Japan's position and proposal on draft of OBD-gtr

3 Feb 2014

**Ministry of the Environment(MOE), Japan
&
Ministry of Land, Infrastructure,
Transport and Tourism (MLIT), Japan**

OBD Emission Threshold

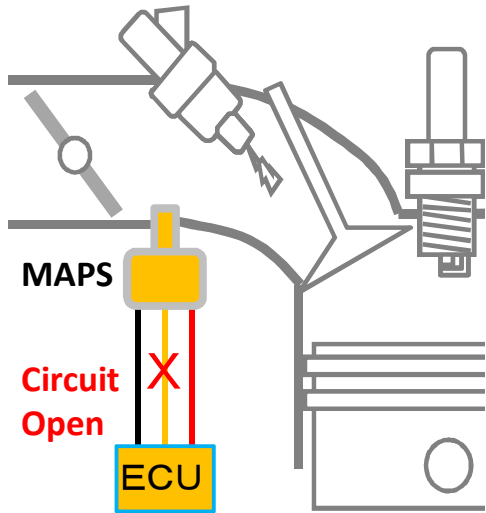
Unnecessary
OBD emission
threshold

Reasons why OBD threshold is unnecessary for digitally detected failures on the next slide.

Circuit Diagnostics <Sensor>

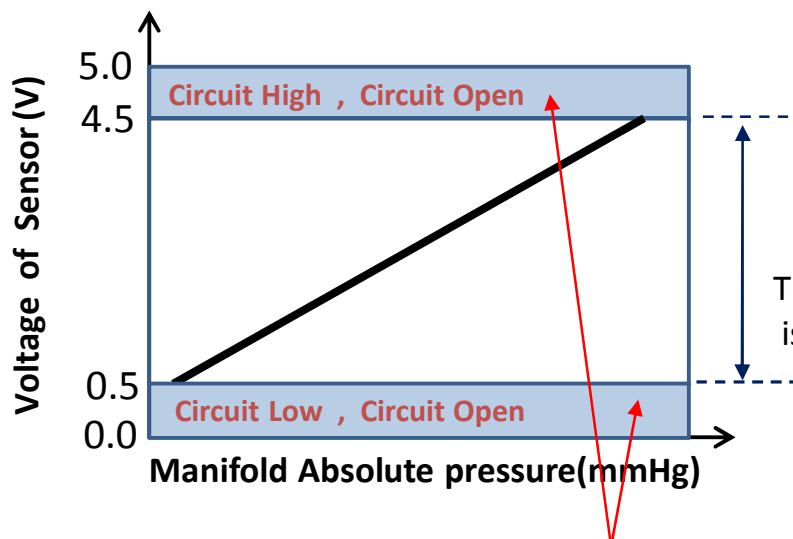
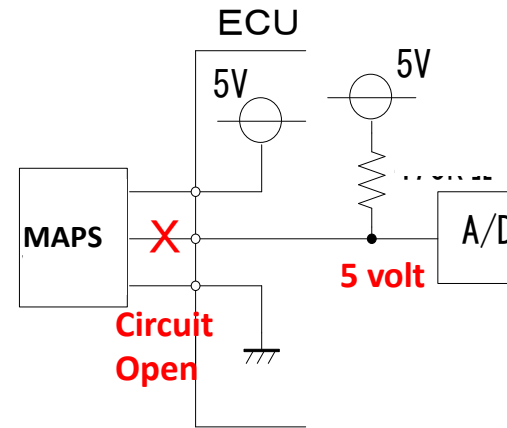
Emission threshold is unnecessary because it is judged by the threshold of circuit diagnostics [example : threshold of circuit diagnostics is over 4.5 volt]

The malfunction of the sensor is detected when the voltage value does not fit within this range.

Circuit Diagnostics <Sensor(pulse output type)>

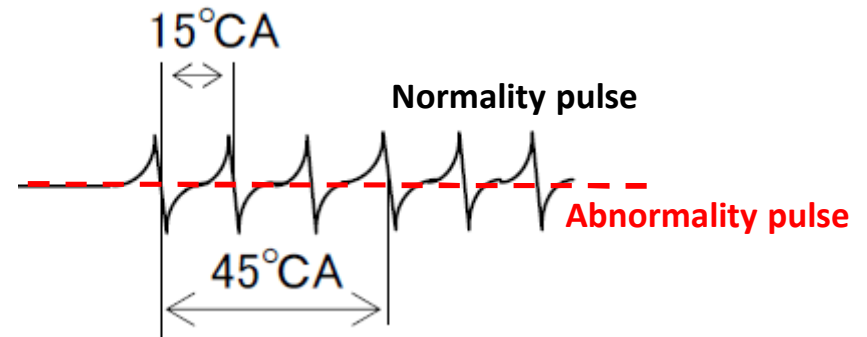
Emission threshold is unnecessary because it can be detected by the absence of the pulse.

The malfunction of the sensor is detected when the pulse signal from the sensor fails. However, this detection requires another condition as well that the crank shaft is rotating, so it is necessary to make judgment by both of information of the pulse and starter signal.

Circuit Diagnostics < Solenoid >

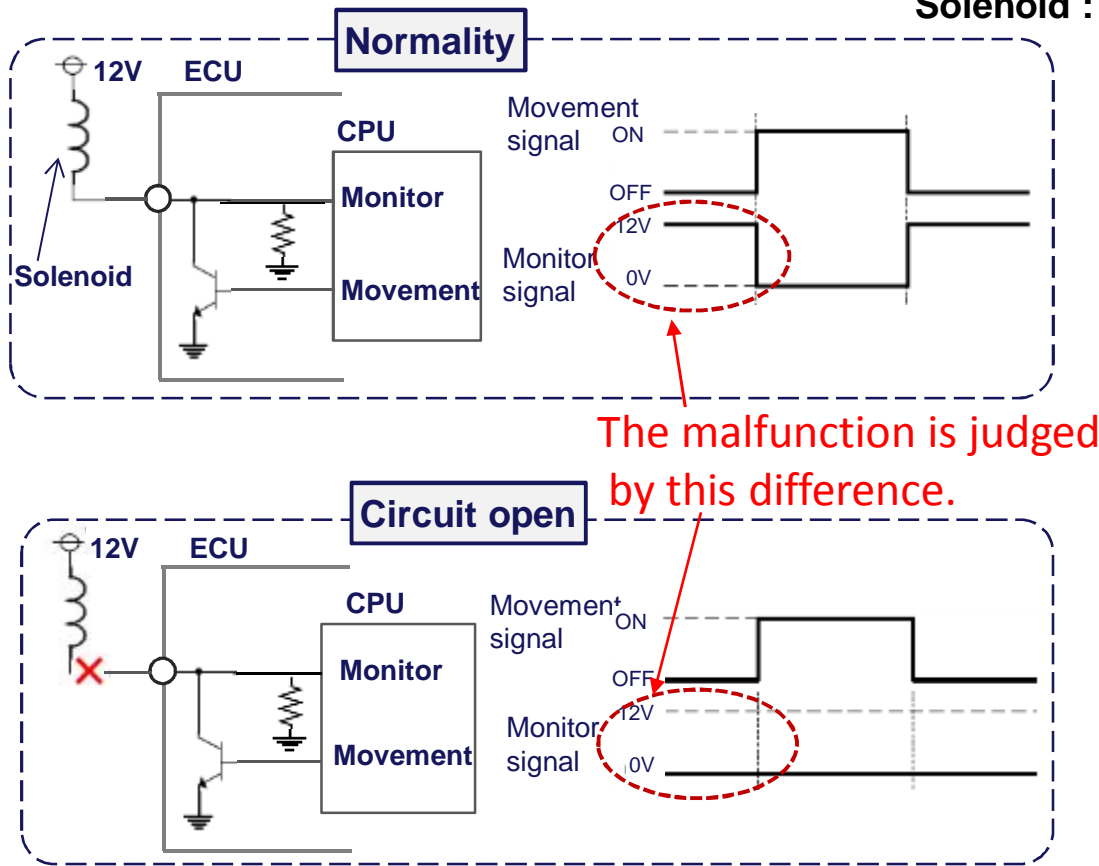
The malfunction is judged by the level of monitor signal.

Emission threshold is unnecessary because it can be judged by the signal condition.
